Addendum No. 1 – Clarification of questions raised at December 3, 2013 pre-bid meeting

Addendum No. 2 – Clarification of Manufacturer Change for Inverter and Inverter Warranty

Addendum No. 3 – Answers to questions received by December 13, 2013 deadline

GENOVEVA CHAVEZ COMMUNITY CENTER

SHEET NO.
E-4

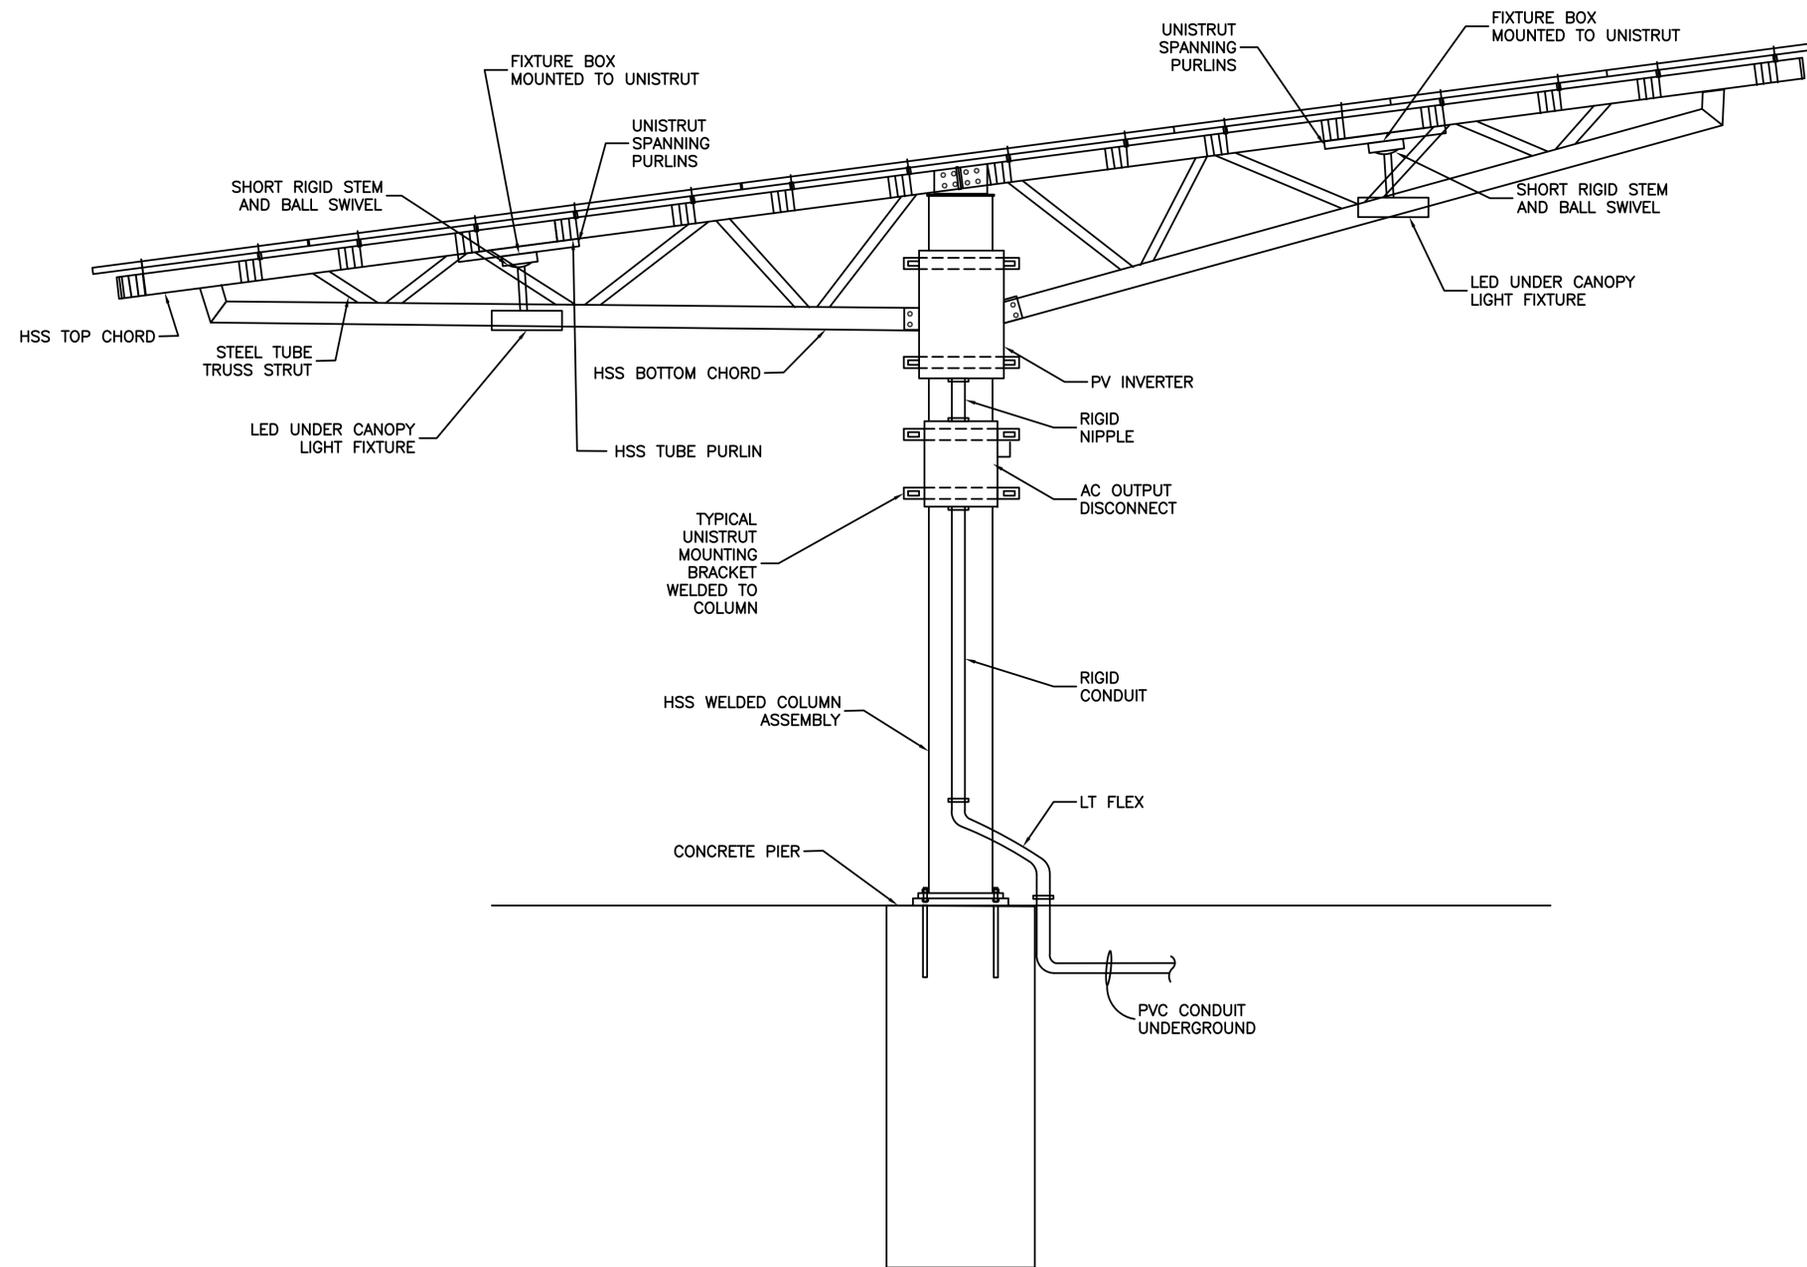
4. Drawing E-4 shows Unistrut welded to the carport column assembly. Would tek screws be an acceptable alternate?

PROJECT: CITY OF SANTA FE
CHAVEZ CENTER PV
SHEET TITLE: 96KW PV SYSTEM
ONE-LINE DIAGRAM

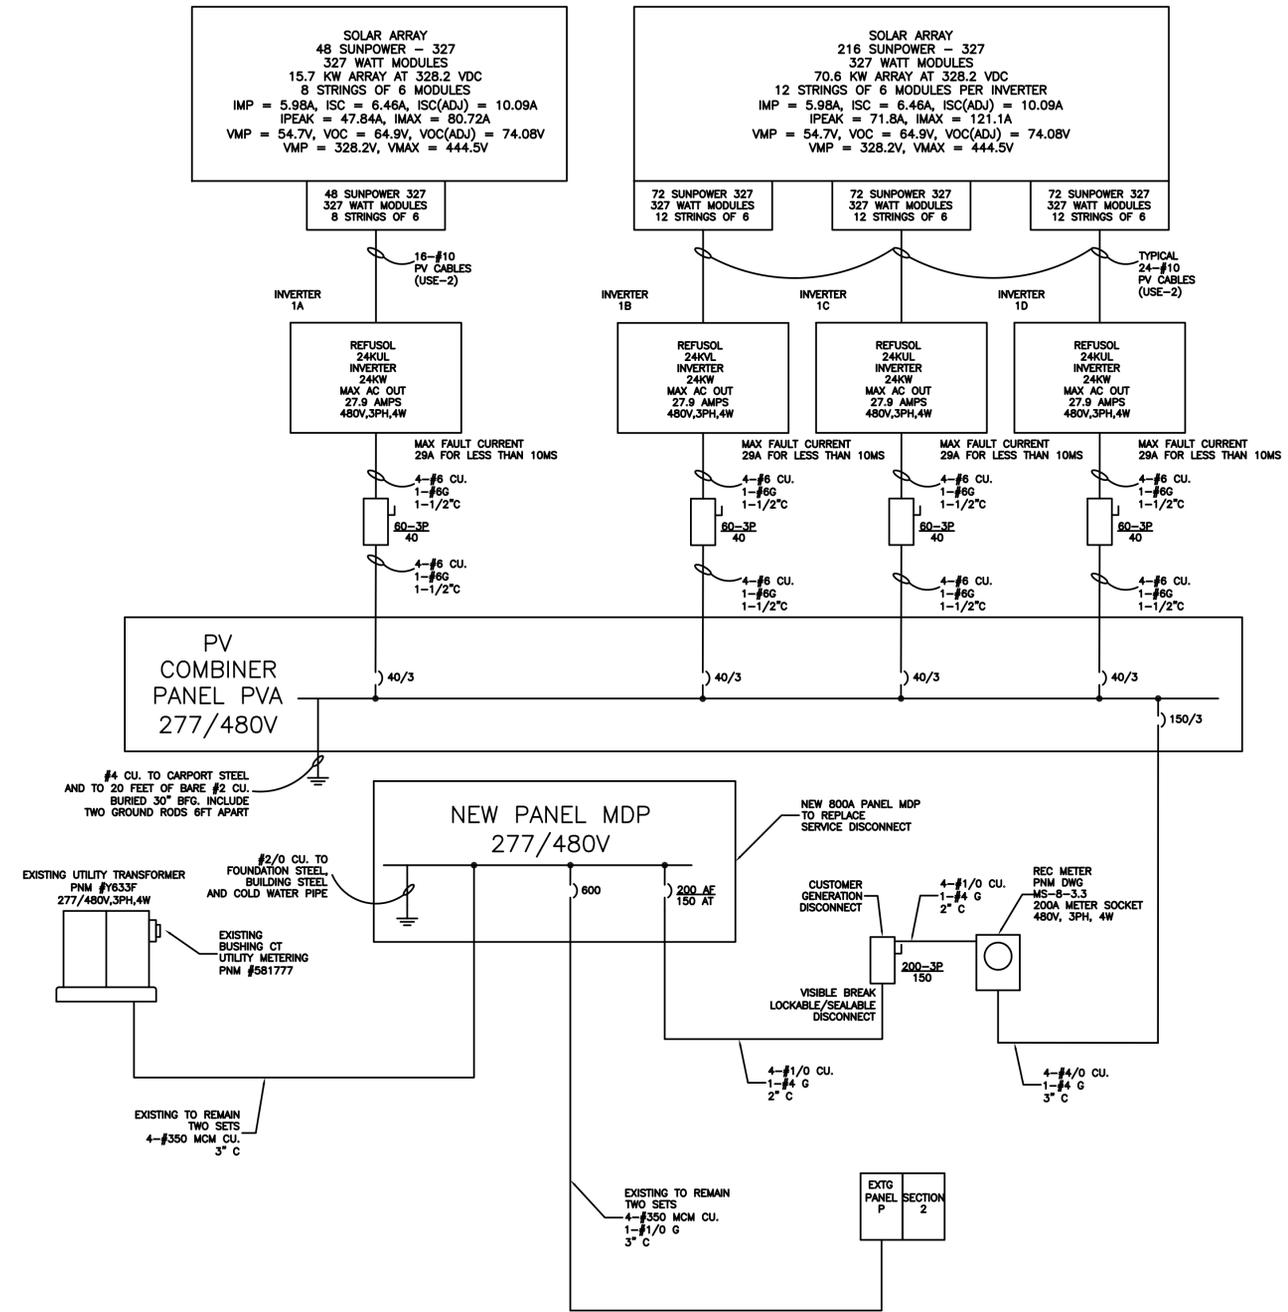
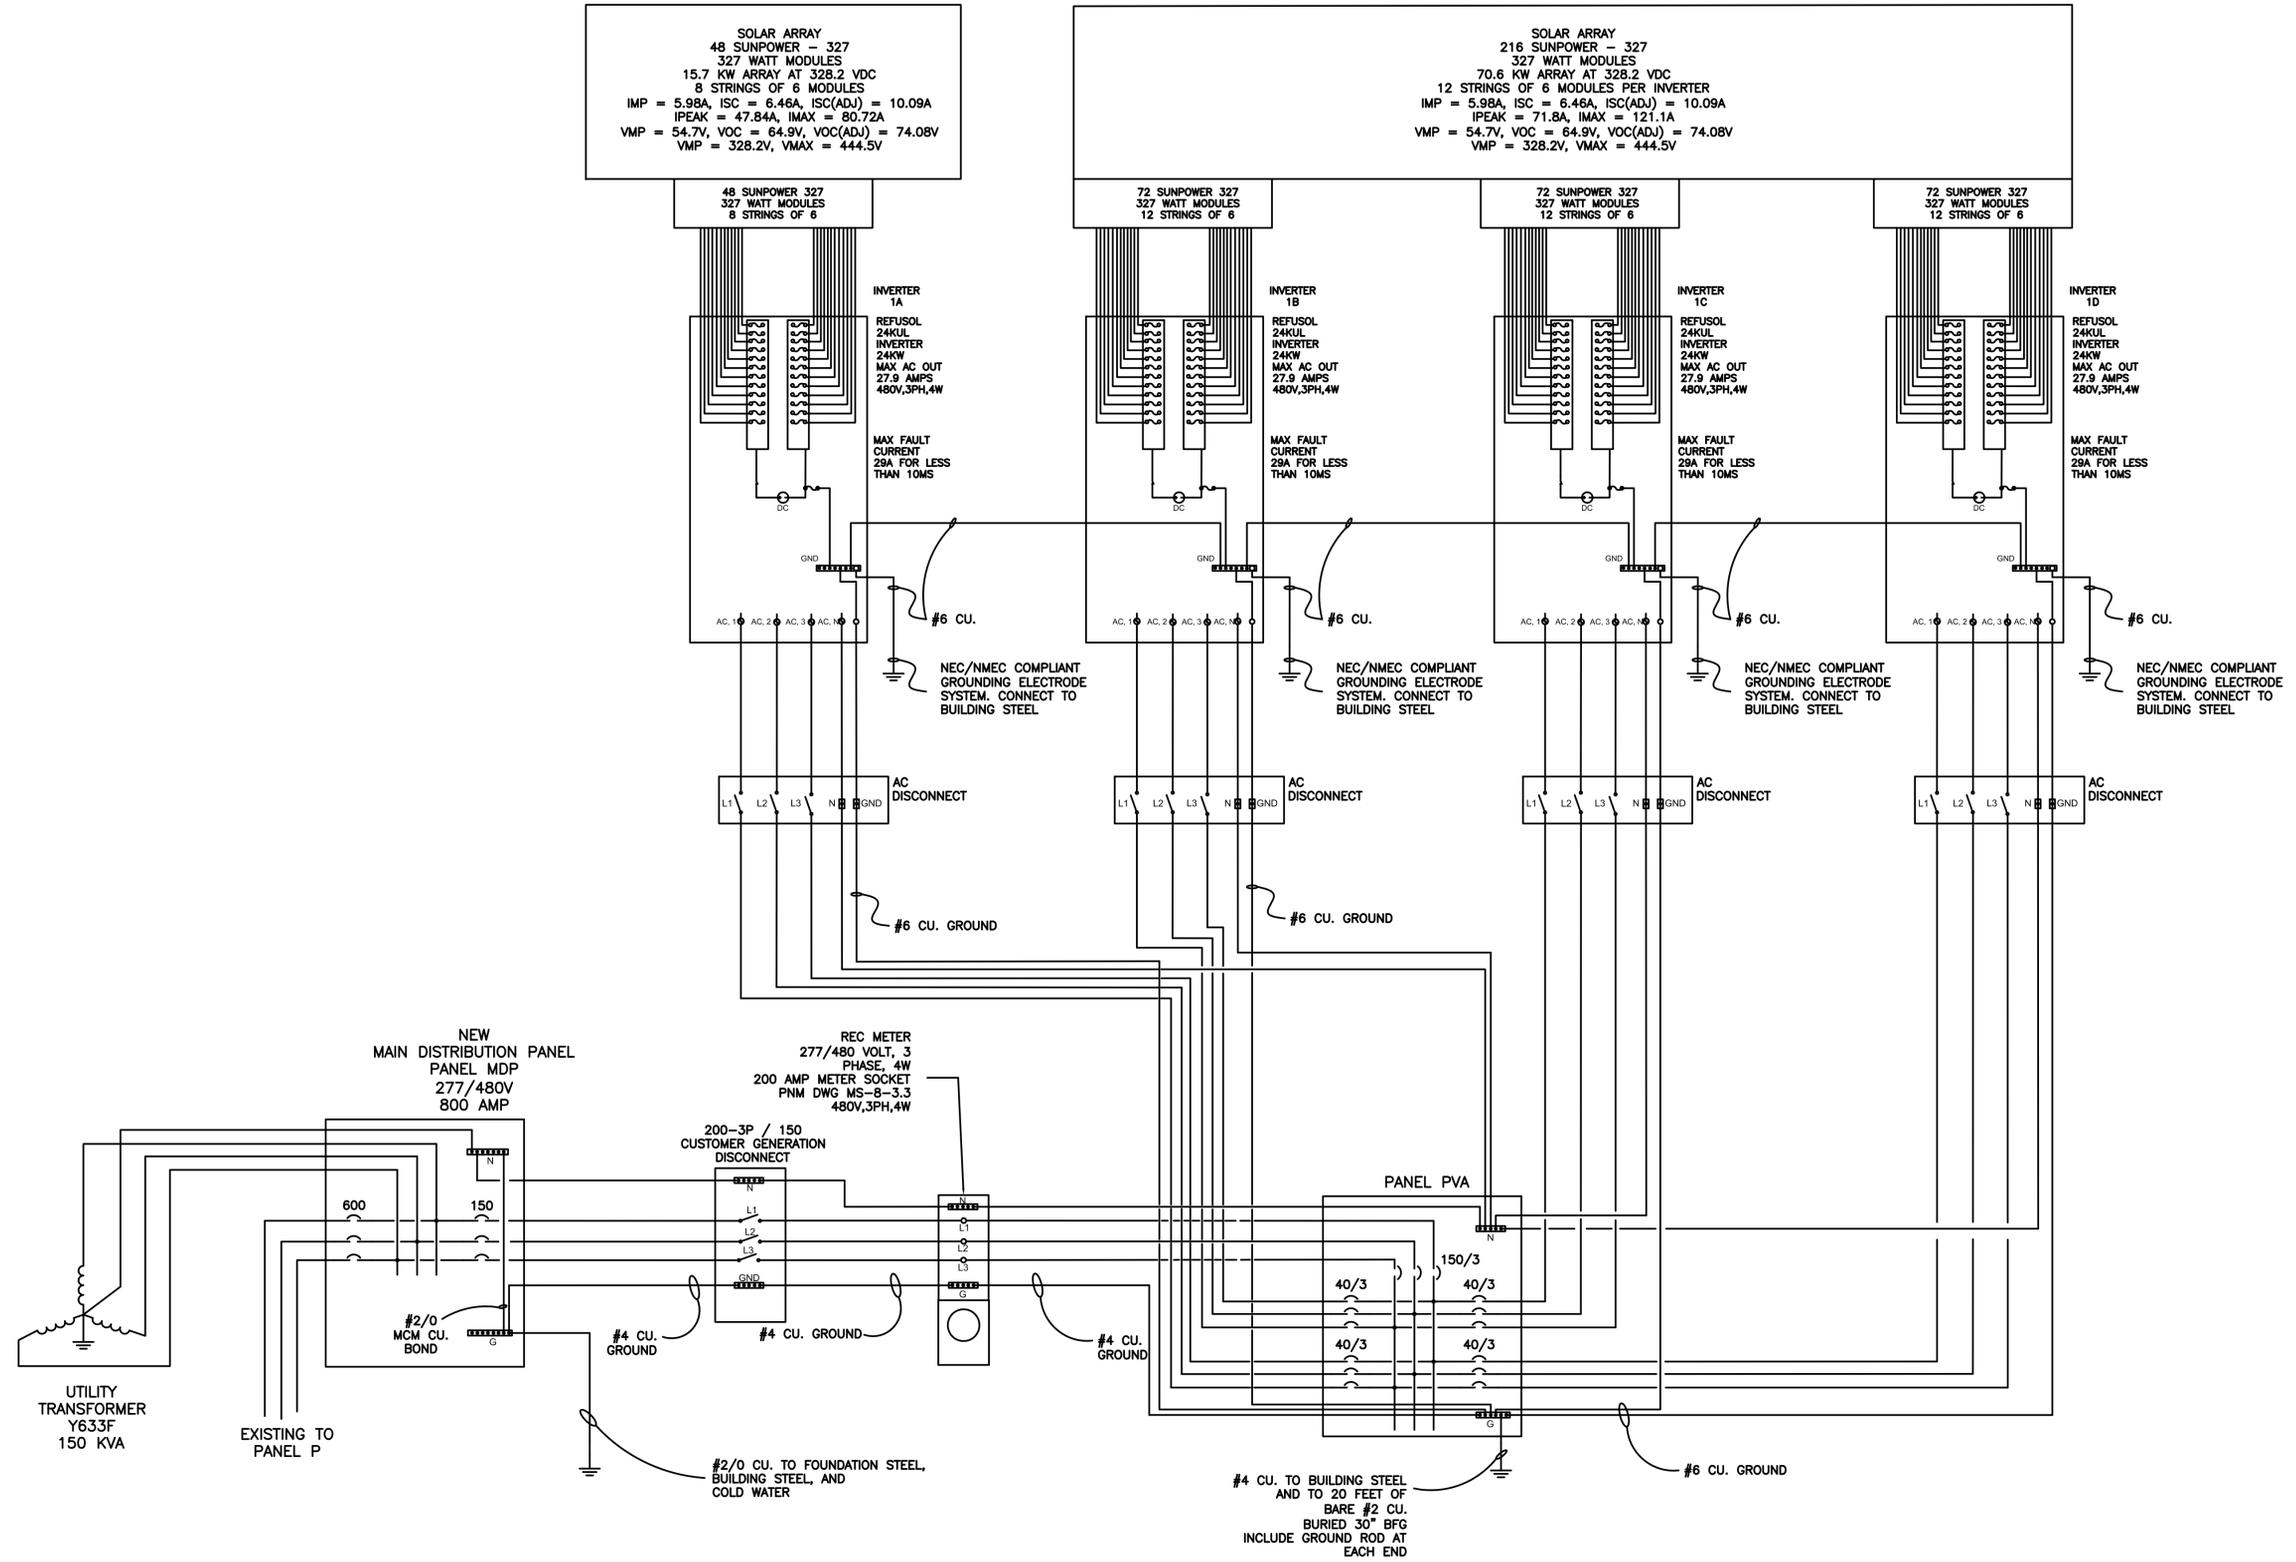
7. Clarify that all panels are 480/277 VAC, Panel MDP Drawing EA-3 has 120/208 VAC in table.

SHEET NO.
EB-4

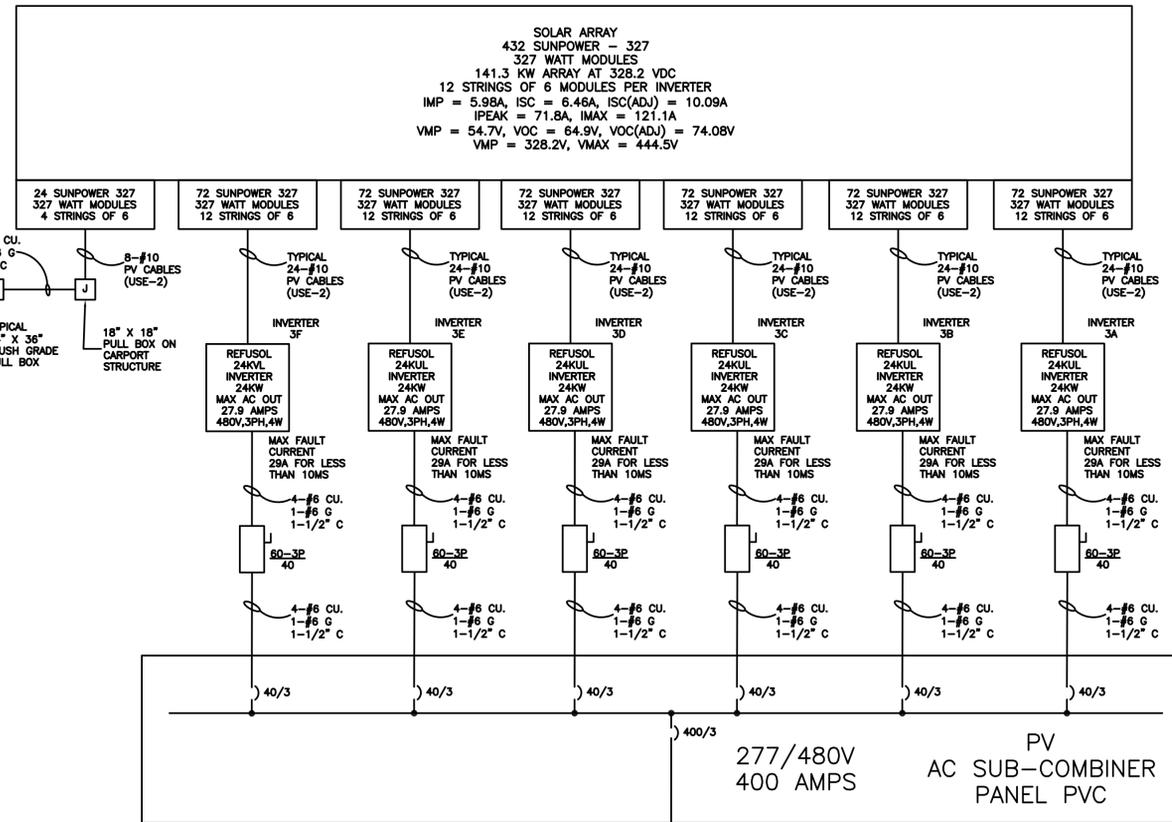
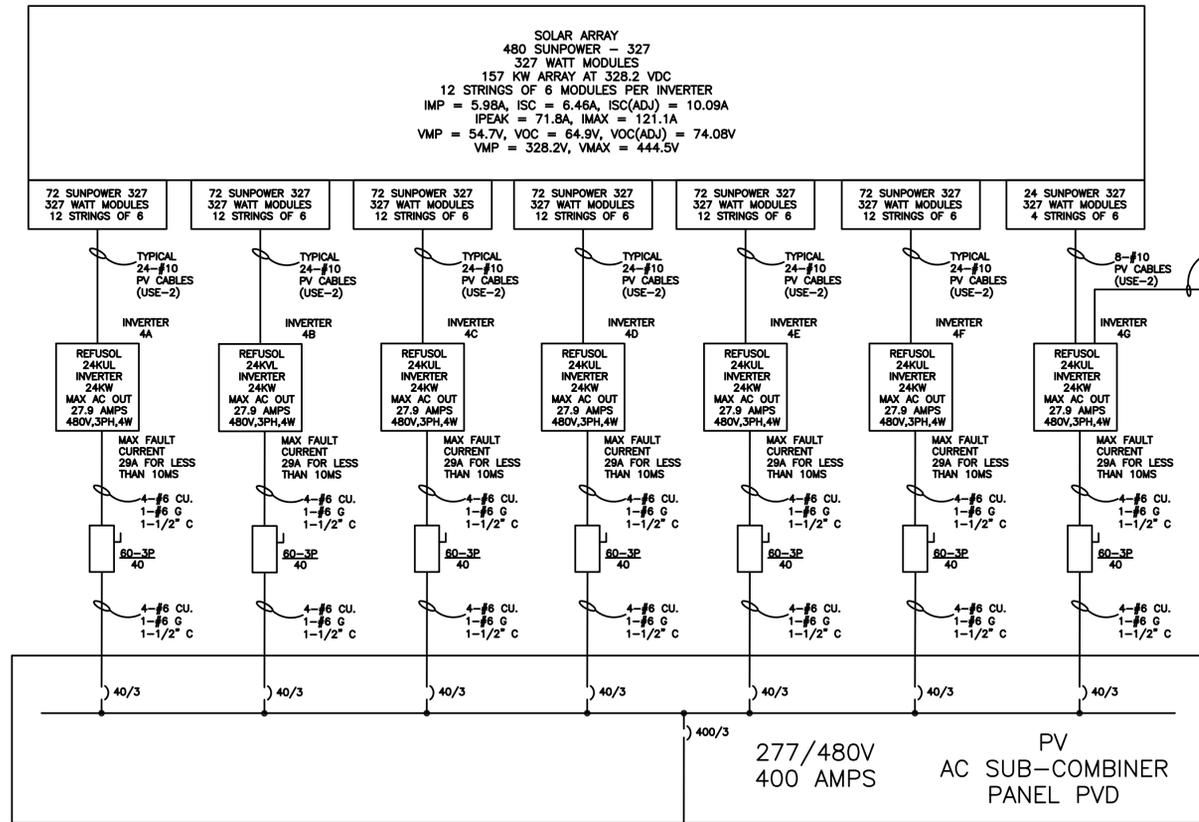
For power outages longer than 4 hours, contractor shall provide a portable generator with sufficient capacity to operate a 150 ton Ice Rink chiller. For bidding use, 400KW site rated generator operating at 277/480 Volts. Include portables cables, connection to chiller control panel, and re-termination to main switchboard after outage is complete. Location of chiller is within 50 feet of main switchboard shown on sheet EB-4.

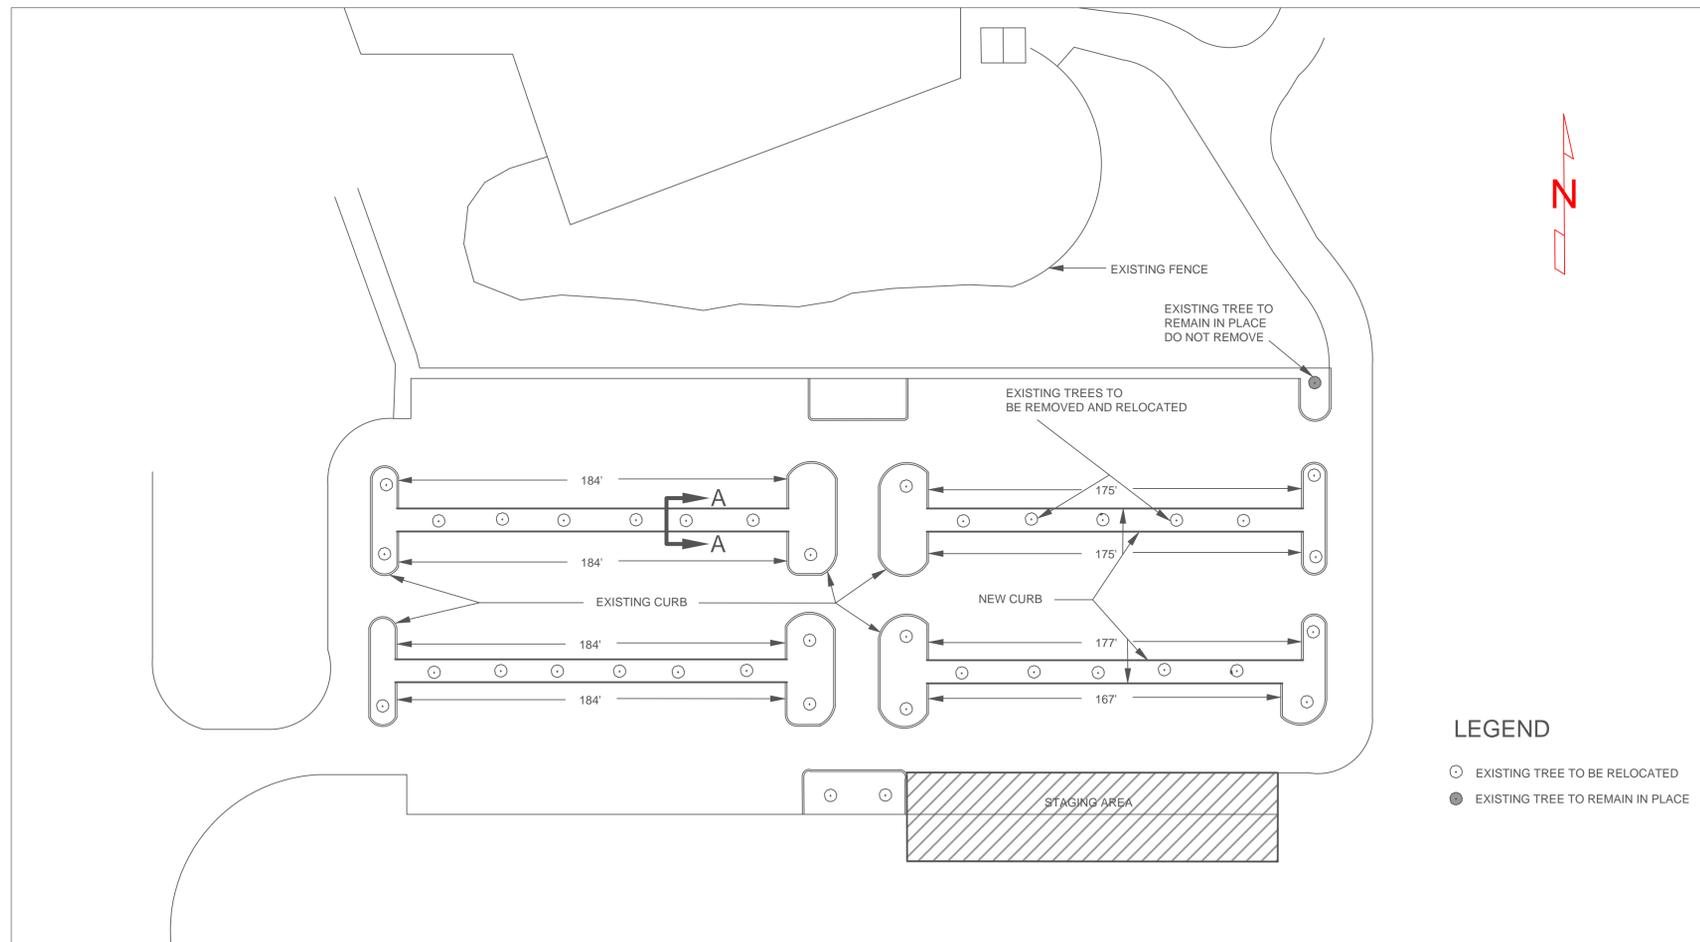
3. The location of the staging area for the project is at the southeast corner of the parking lot as shown on the Parking Lot Detail drawing which is the last page of the bid documents.
